4.1 Site Plan - Mountain America Credit Union

Date: June 21, 2023
From: Cache Hancey, Planner & Business Advocate
To: Planning Commission
Item: Mountain America Credit Union Site Plan (PLAN 23-010)
Applicant: Brooke Bean, Sanders Associates Architects

**RE: MOUNTAIN AMERICA CREDIT UNION THE YARD BRANCH
SITE PLAN REVIEW 1ST REVIEW COMMENTS – SAA RESPONSE**

C1.1

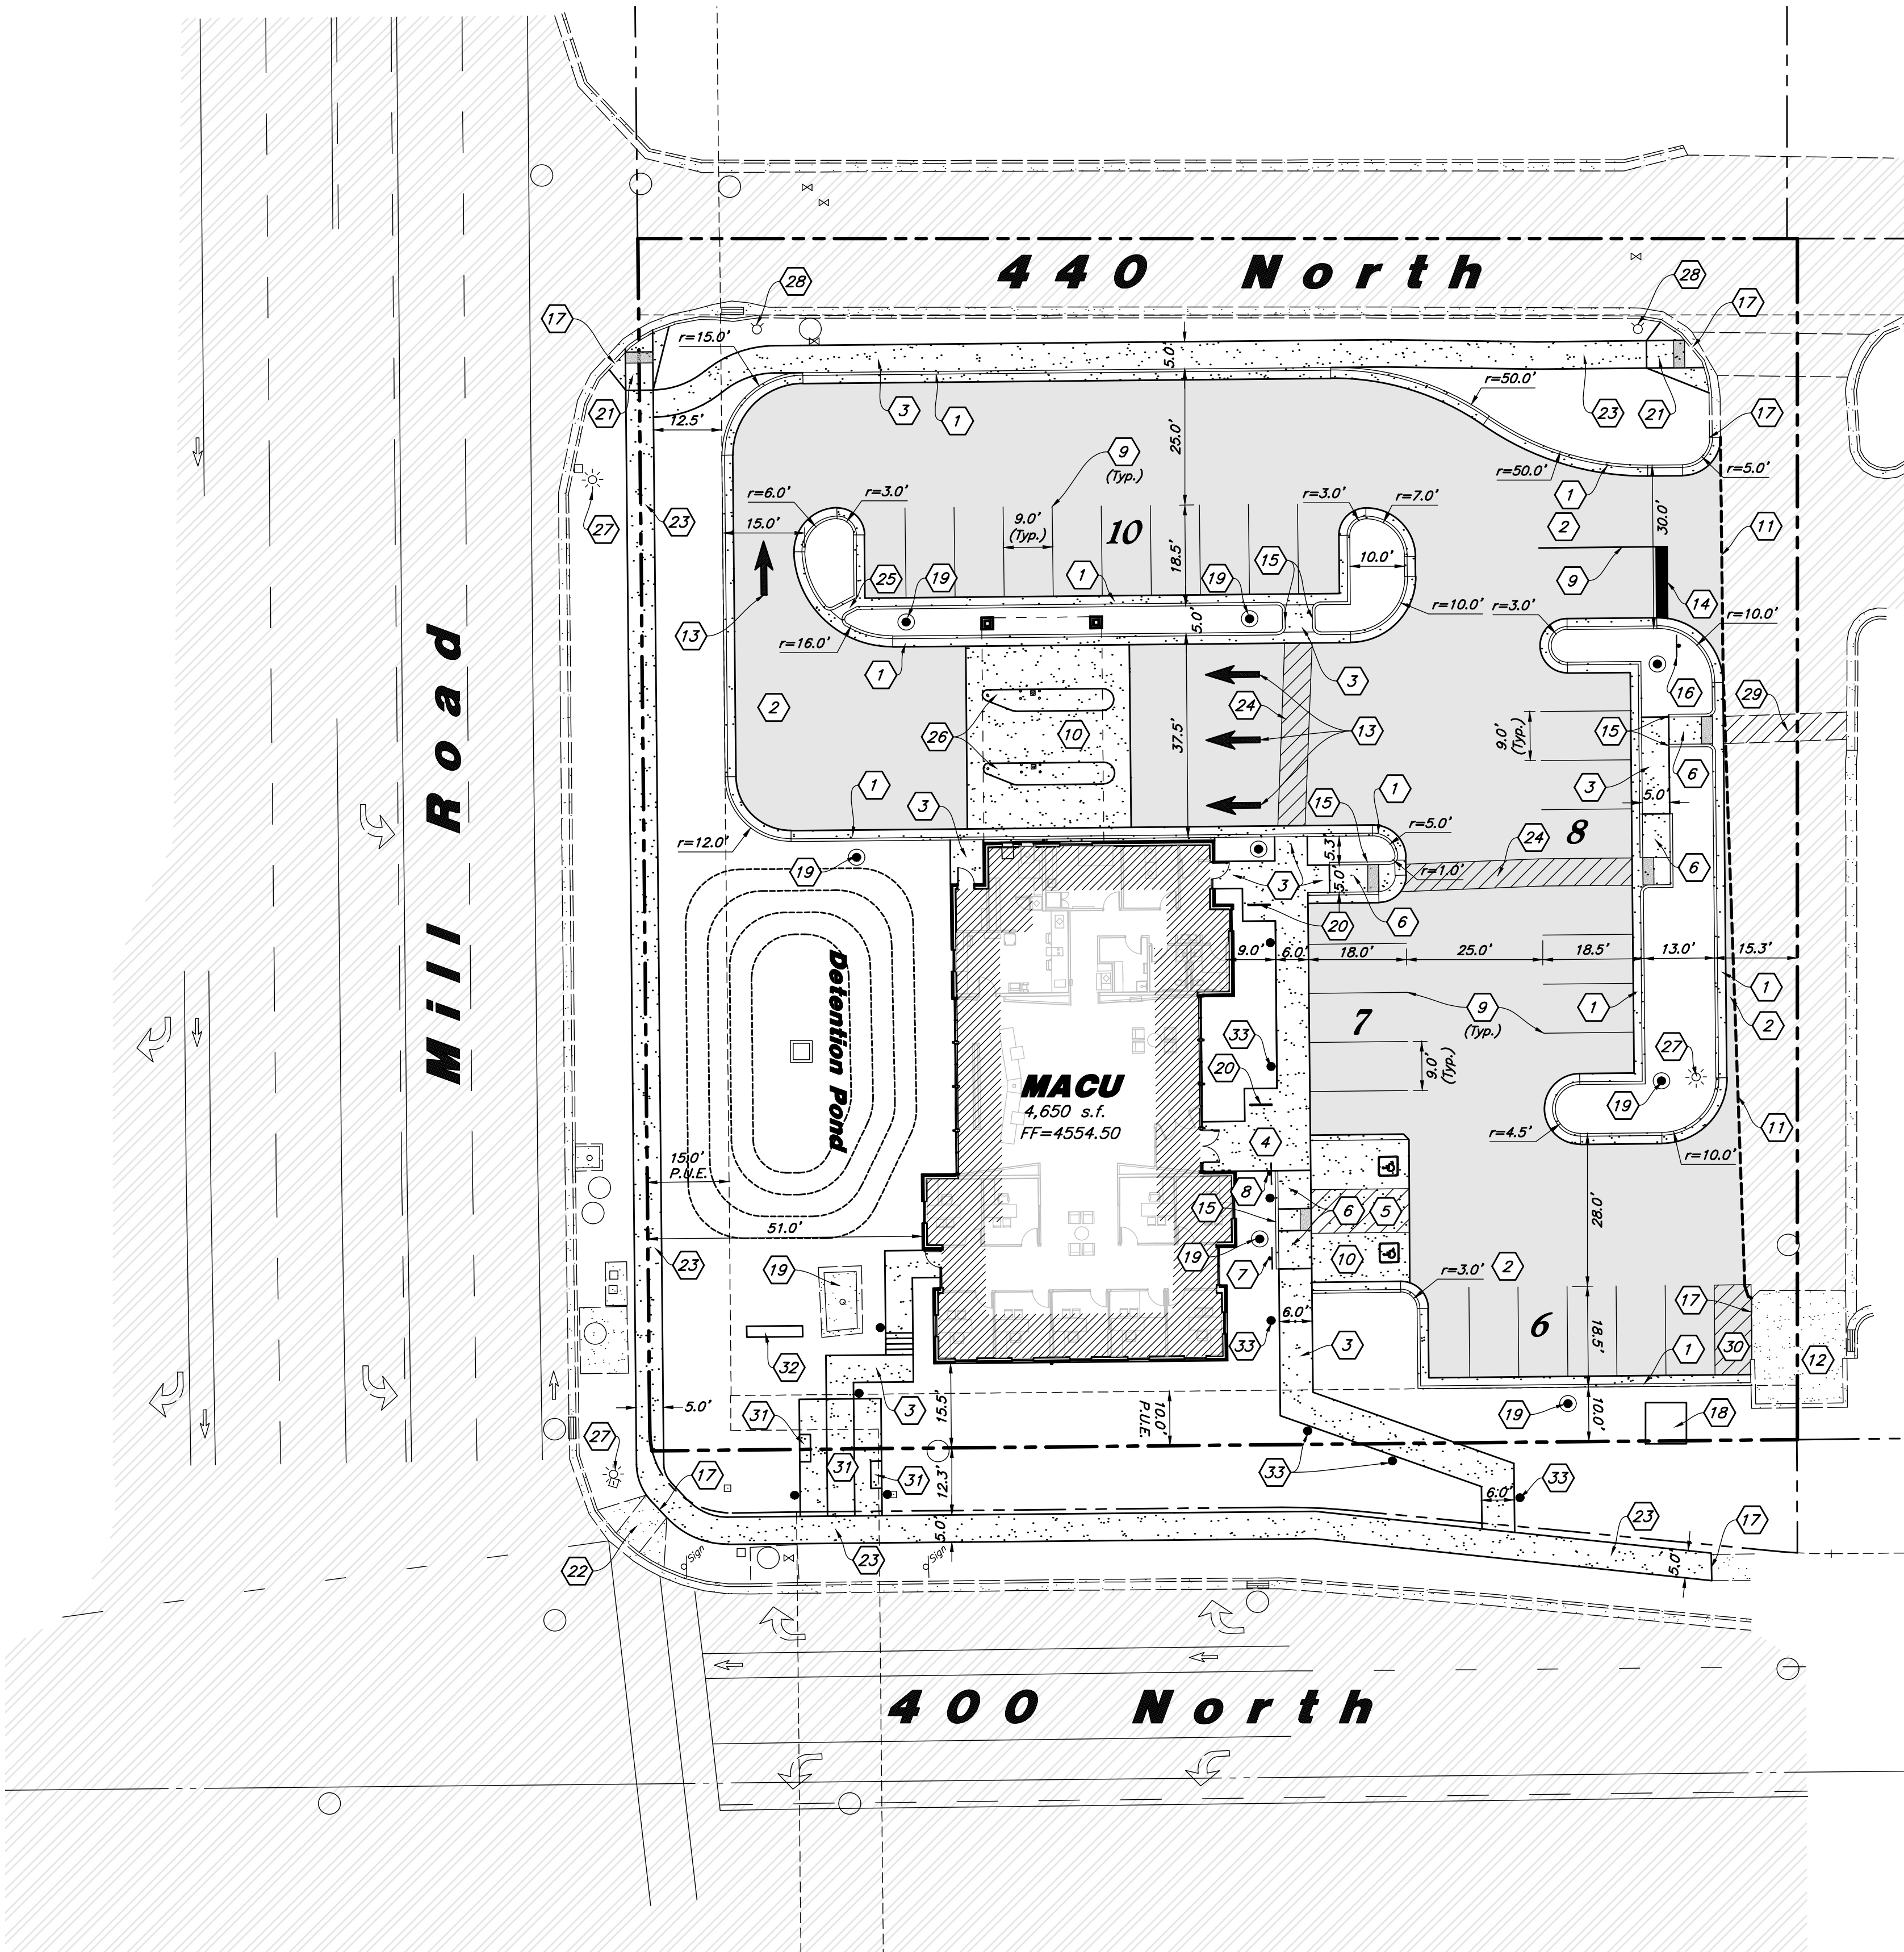
3. *Building must have an orientation to the street to encourage a pedestrian relationship. Currently, the front of the building faces east towards the rear. You must have a usable public entry on the 400 N side or Mill Road side of the building. Bringing the building closer to the street, while maintaining the required 20' setback off 400 N, can further enhance that pedestrian relationship.*
SAA/AWA Response: An entrance has been added to the Mill Road side of the building. The public gathering space has been added on the sidewalk to this entrance to encourage a pedestrian relationship. The building can not be moved closer to Mill Road due to a large piece of electrical equipment that is existing on the site.

4. *Provide a differentiated, safe access route for pedestrians across the northern parking lot. These pedestrians will be interfacing with moving vehicles at the drive-thru tellers regularly.*
AWA Response: Striping and crosswalk area has been added
